# Access Compliance Report

## Public Rights-of-Way

### (Curb Ramps)

Intersection ID: 13806	Main Street: S_TRYON_ST	Cross Street: WEST_BV	Location: E
ADA ID: FAB0E42B1CA7	Ramp Type: Perp	Initial Pass/Fail: Fail	Overall Compliance: No
Severity Score: 13.75			
Codes/Mitigation Info/Possible Solution		Field Measurements/Component Compliance

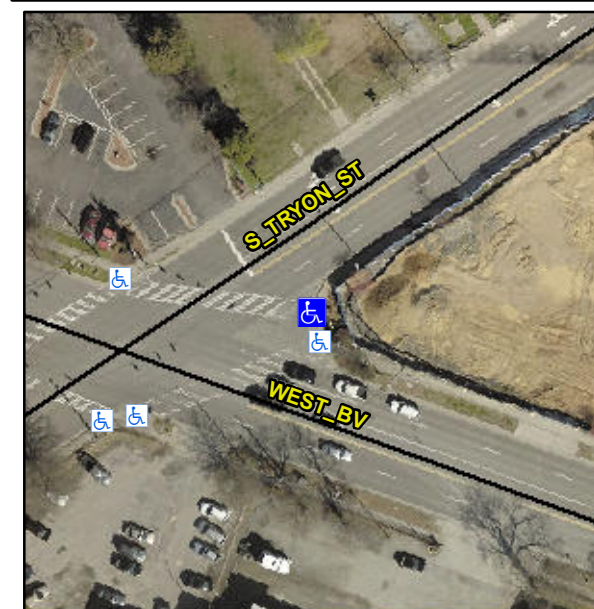
**Not Found, R304.2.2, R304.5.3**

Compliance	Description	Data	Compliance	Description	Data
N/A	Ramp Length (in)	60.0	No	Ramp Slope (%)	9.9
Yes	Ramp Width (in)	48.0	No	Ramp XSlope (%)	4.1
N/A	Flare Type LT	N/A	N/A	Flare Type RT	N/A
N/A	Flare Slope LT (%)	N/A	N/A	Flare Slope RT (%)	N/A
N/A	Flare Traversable LT?	N/A	N/A	Flare Traversable RT?	N/A
N/A	Landing Length (in)	N/A	N/A	DWS Provided?	N/A
N/A	Landing Width (in)	N/A	N/A	DWS Contrast?	N/A
N/A	Landing Slope (%)	N/A	N/A	DWS Length (in)	N/A
N/A	Landing X Slope (%)	N/A	N/A	DWS Full Width?	N/A
N/A	Landing Curb? (Y/N)	N/A	N/A	DWS Offset (in)	N/A
N/A	Shared Landing?	N/A			
N/A	Gutter Ponding?	N/A	N/A	Gutter Slope (%)	N/A
N/A	Gutter Lip Ht (in)	N/A	N/A	Gutter X Slope (%)	N/A
N/A	Painted X Walk1?	Yes	N/A	Painted X Walk2?	N/A
	X Walk 1 Direction	To NW		X Walk 2 Direction	N/A
N/A	X Walk 1 Width (in)	112.0	N/A	X Walk 2 Width (in)	N/A
	X Walk 1 Slope (%)	0.9		X Walk 2 Slope (%)	N/A
	X Walk 1 X Slope (%)	2.1		X Walk 2 X Slope (%)	N/A

**Remove & Replace Entire Ramp.**
